Endangered Species Act Section 7 Consultation with the National Marine Fisheries Service (NMFS) for  
Oyster Creek Nuclear Generating Station Shutdown and Decommissioning

Docket No. 50-219; License No. DPR-16

Responses to the NMFS's May 24, 2019, Additional Information Requests

June 11, 2019

**Figure 1. Location of Barge Landing on Oyster Creek Site**

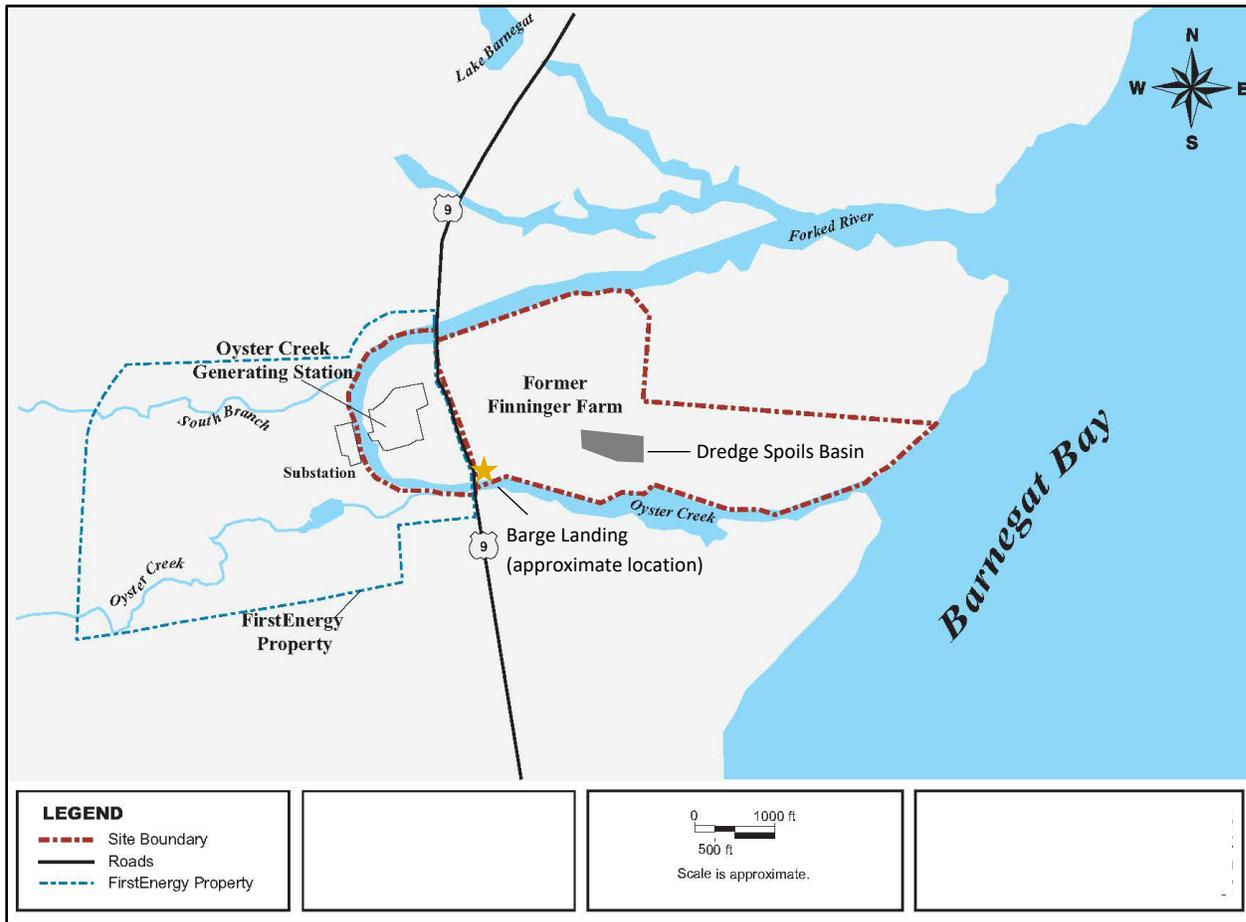
- 3. You and Exelon note that dredging may be necessary to facilitate the movement of plant components off site via barge. These activities will need to be considered in the reinitiation. It is my understanding that dredging has occurred in the area previously. It may be reasonable for the purposes of the section 7 consultation to assume that past dredging practices (i.e., dredge type) would be used for future dredging. We are not aware of any impingement or entrainment of sea turtles in a suction dredge. You would need to consider any impacts to sea turtle forage and other habitat features. I can provide you with an example of a dredge analysis if that would be helpful. Similarly, because vessel strike is a concern for sea turtles, you will need to consider effects of an increase in vessel traffic (i.e, the barges). I've attached a copy of the consultation we did for the North Anna project that considered use of a temporary offloading facility and may be helpful to you.**

During the decommissioning period, Exelon (2018b) anticipates that it will ship dismantled large plant components by barge from an existing barge landing at the north bank of Oyster Creek immediately east of U.S. Highway 9. The licensee has periodically used this barge landing during both the construction and operation periods to transport large components to and from the site. The barge landing contains no permanently installed equipment or infrastructure, and Exelon anticipates that none would be needed to support barge traffic and loading associated with decommissioning. In connection with barge traffic, Exelon (2018b) anticipates that dredging in Oyster Creek between the barge landing and Barnegat Bay to an unknown depth could be required to provide enough depth for barge vessels to pass. Dredging may also be required in Barnegat Bay itself to allow passage of loaded barges between the mouth of Oyster Creek and Barnegat Inlet. Any dredging would require Exelon to obtain U.S. Army Corps of Engineers and appropriate New Jersey Department of Environmental Protection, Division of Land Use Regulation, permits. Exelon (2018b) would dispose of dredge spoils in an existing State of New Jersey dredge spoils basin on Exelon property east of the barge landing. Figure 1 below depicts the location of the barge landing and the dredge spoils basin within the former Finnigan Farm portion of the Oyster Creek site.

For the purposes of its analysis, the NRC staff assumes that barge vessel traffic would only occur during the large component removal phase of the decommissioning period. Exelon (2018b) currently anticipates that this phase would require one year to complete and would occur between June 2075 and June 2076.<sup>2</sup> The NRC staff conservatively assumes that large component removal would necessitate up to four barge loads such that barge vessel traffic would occur quarterly for the one-year large component removal phase. The NRC staff also conservatively assumes that prior to this phase of decommissioning, dredging would be required to allow for vessel traffic. The NRC staff assumes that dredging would take place in the first half of 2075 and that dredging would only occur once because large component removal would be completed within a year. Based on information on past dredging within the area, one year is not enough time for sediment to build up to a degree that would necessitate further dredging. Finally, the NRC staff assumes that cutterhead
